SUBJECT 19EA IMPELLER DISPLACEMENT SWITCH WIRING

FIELD EXPERIENCE REPORT 73-6

Fig. 1
Before Modification

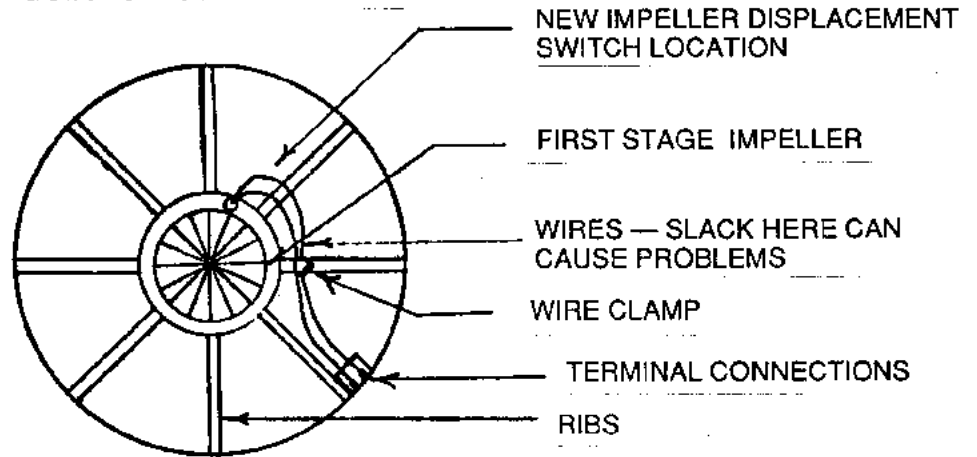
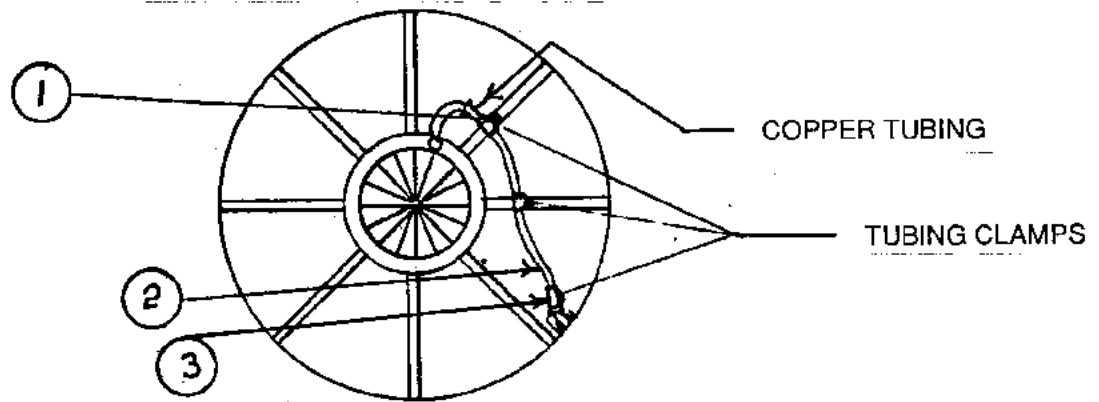
A recent compressor redesign has relocated the impeller displacement switch on 19EA(1&5) compressors to an approximate 12:30 position. Due to the length of wires, the slack formed allows wires to possibly be drawn into the impeller causing an open circuit and resulting in compressor shutdown (see Fig. I).

1. Inspect wires to see if they are frayed or broken. Replace, if necessary.
2. Install the three (3) tube clamps as shown (see Fig. 2). Position so that wires will be taut but not strained.
3. Install copper tubing with ends flared (to prevent cutting of wire insulation).
4. Fish wires through tubing and connect.
